- 4. Tatum Denise Subdivision Derks Lake Addition
KPB File 2022-155**

ITEM 4 – TATUM DENISE SUBDIVISION DERKS LAKE ADDITION

STAFF REPORT

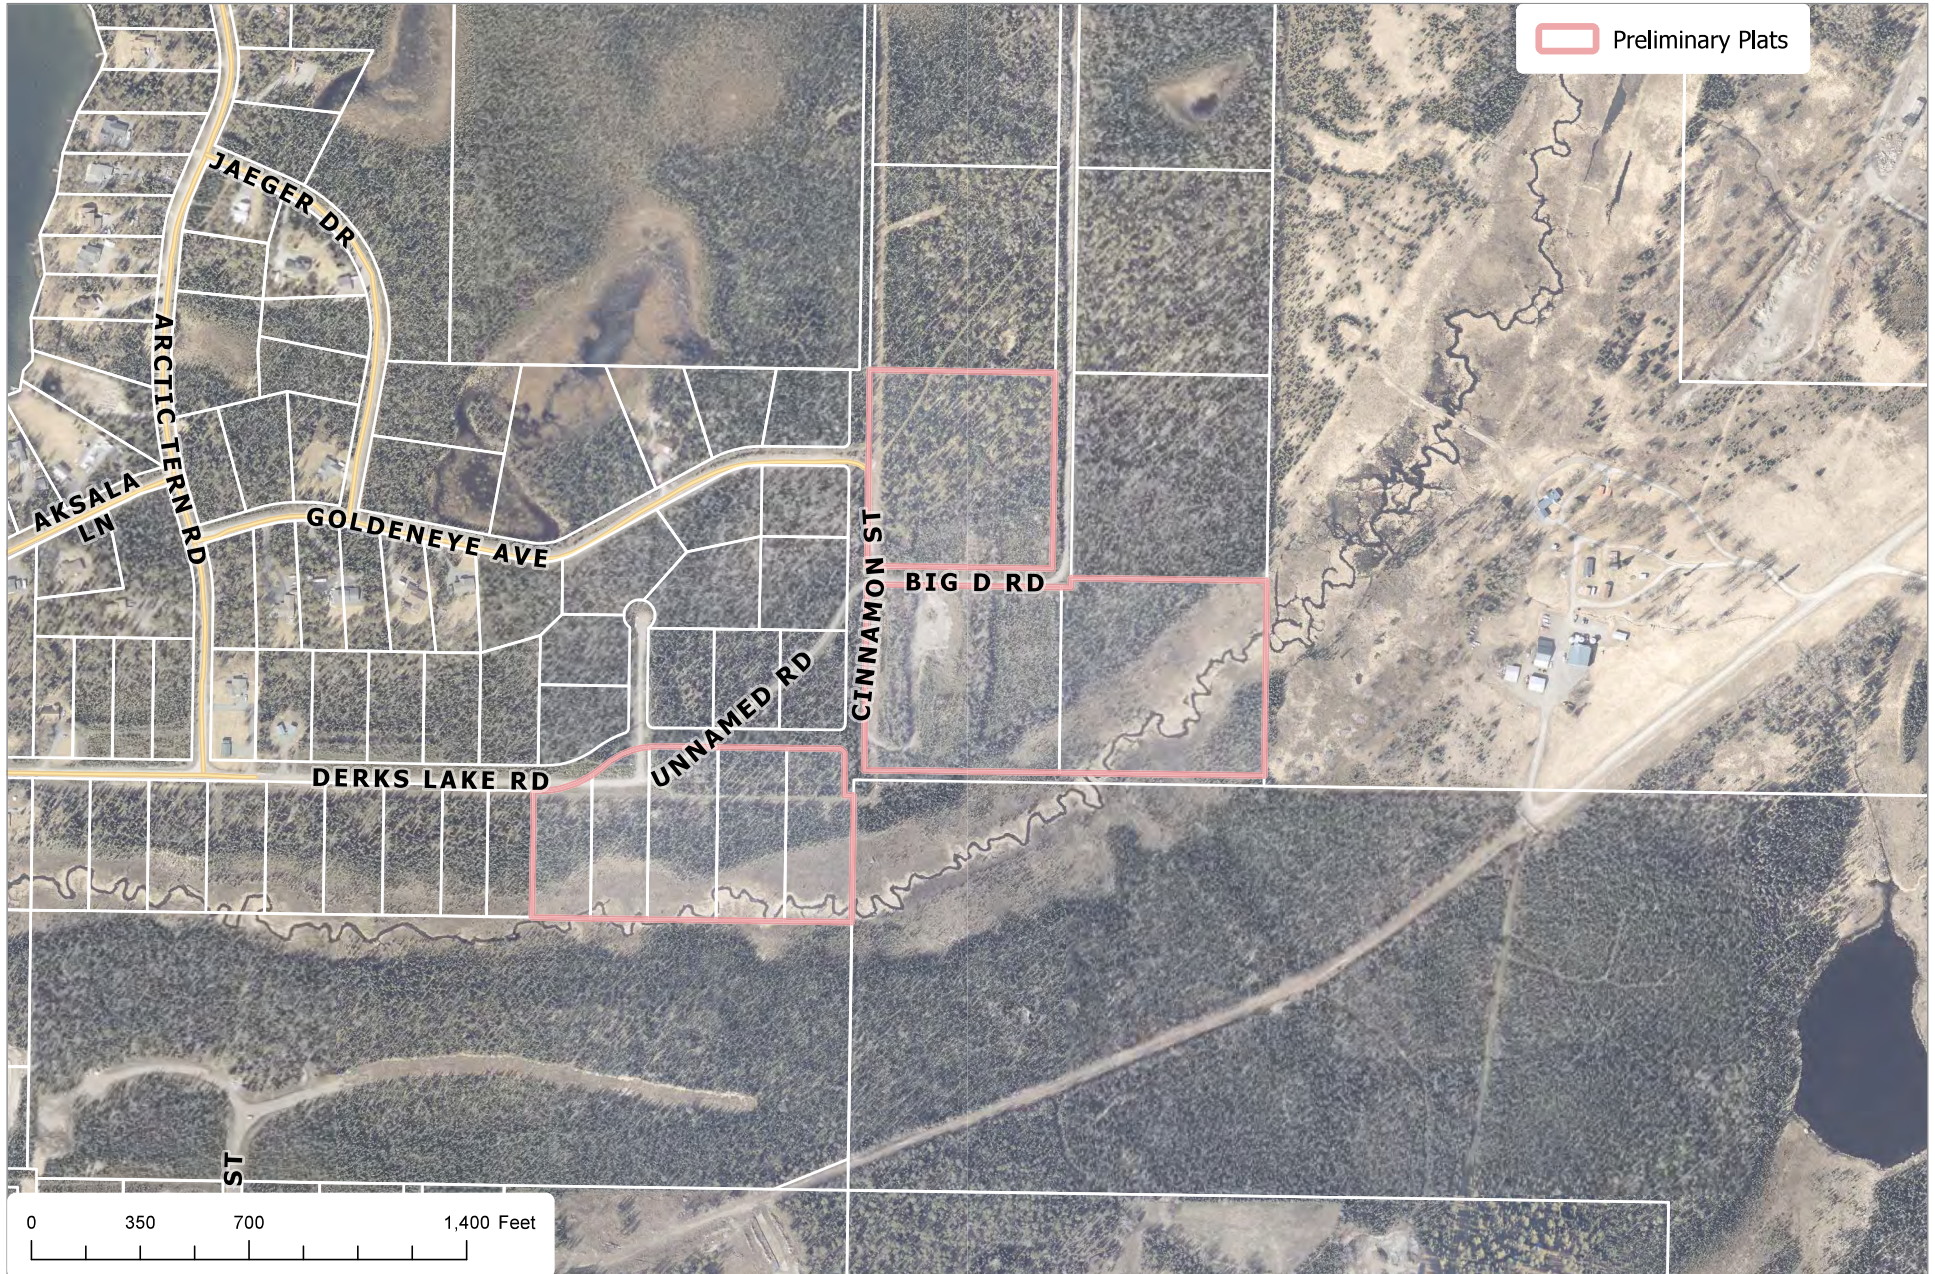
It does not appear that a street name has been assigned to the dedication within the section line easement to the south of Tract 4A. **Staff recommends** a width label be added with a label indicating it is an unnamed right-of-way.

Site Investigation: The low wet areas are depicted on the plat and a wetland determination note is present. The location of Soldotna Creek is shown with the anadromous plat note present. **Staff recommends** the low wet areas be depicted on the final plat and Soldotna Creek depiction remain.

Contours are depicted on the plat with some areas with steep terrain. The steep terrain is minimal and does not impact the new dedications. **Staff recommends** the steep terrain is not required to be shown on the final plat.

Cinnamon Street is dedicated as 66 feet wide adjacent to the subdivision north of Derks Lake Road. This dedication coincides with section line easements. There does appear to be some steep slopes present within the eastern portion of the right-of-way adjacent to proposed Tract 1A. Per the KPB Planner's review, parent Tract 1 has a prior existing use on the property. Imagery appears to show some areas where the lot has cleared and possible material extraction has occurred. It is difficult to determine if the area within the right-of-way dedication were part of an access road or if excavation occurred that caused the steep slopes. **Staff recommends** centerline profiles and cross sections be provided for that portion of Cinnamon Street to verify if the street can be built to borough standards and to determine if additional right-of-way width or easements are required.

Utility Easements The lots south of Derks Lake Road had the code required utility easements granted when subdivided by Tatum Subdivision, Plat KN 2021-15. When the lots were replatted, the utility easements associated with rights-of-way that were vacated were also vacated but new easements were granted along the new dedications. The tracts did not have utility easements granted along all dedications. A 5 foot clearing and underground utility easement was granted along portions of Big D Road including the portion proposed for vacation. For the tracts proposed for replatting, Tract 2A had a 10 foot utility easement granted along the northern boundary. Tract 1A and Tract 2A were also subject to a 20 foot utility easement 50 foot east of section line along the existing powerline on the western boundary of the lots. This would result in a 17 foot utility easement along Cinnamon Street. **Staff recommends the previous platted utility easements be depicted with labels stating the plat creating the easement.**

| HEA | Locate and depict the overhead and primary electric line on the final plat. Provide a label or plat note stating, "The existing overhead powerline is the centerline of a 30-foot-wide electric easement, including guys and anchors, granted this plat." |

- C. The location, width, and name of existing or platted streets and public ways, railroad rights-of-way, and other important features such as section lines or political subdivisions or municipal corporation boundaries abutting the subdivision;
Staff recommendation: *Update depiction of Cinnamon Street north of the subdivision as the dedication is only for the eastern 33 feet. Provide information regarding the unnamed right-of-way to the south.*

- D. A vicinity map, drawn to scale showing location of proposed subdivision, north arrow if different from plat orientation, township and range, section lines, roads, political boundaries, and prominent natural and manmade features, such as shorelines or streams;
Staff recommendation: *Due to scale it may just be hard to see but portion of the subdivision is within section 14 and should be included in the depiction.*

Staff recommendation: *The lot to the northwest should be labeled as unsubdivided.*

Add to plat note 9 the meeting consent was granted by the Assembly.
